RED BARN MACHINE	
TITLE MOUNTING RING INPUT MGB	
DWG NO. RBE117-12020-W14	REV 1
UNLESS OTHERWISE SPECIFIED DIMENSIONS ARE IN INCHES	
TOLERANCES ON:	
DECIMALS	FRACTIONS ± 1/32
.XXX ± .005	ANGLES ± .5°
.XX ± .01	
.X ± .1	
UNLESS OTHERWISE SPECIFIED 1. BREAK ALL SHARP EDGES .015 x 45° PR .015 R 2. DIMENSIONAL LIMITS APPLY AFTER PLATING	
SCALE NTS	DATE 7-14-10
SHEET 1 of 1

Under Review Notification

Product #: RBE117-12020-W14
Product Name: Mounting Ring Input MGB

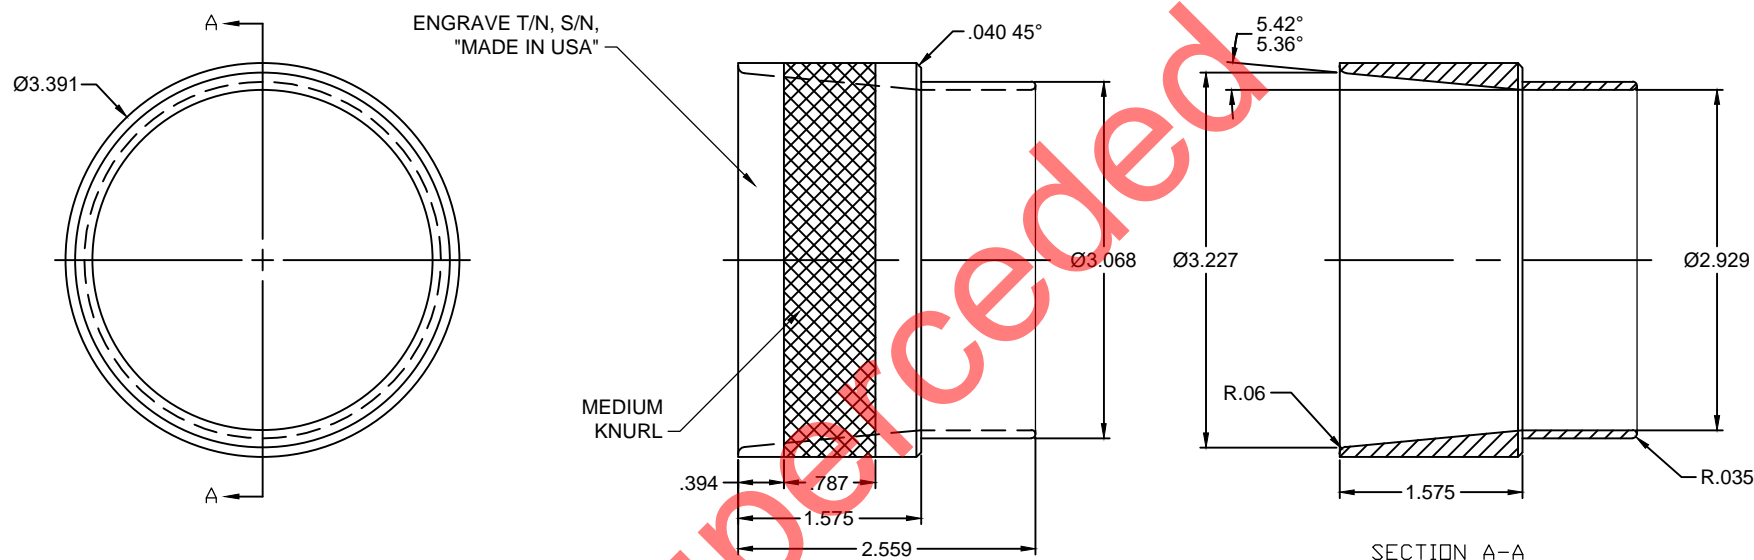
The 2.929 diameter must be increased to avoid interference with mating part
 See NCR19-7374 for more information
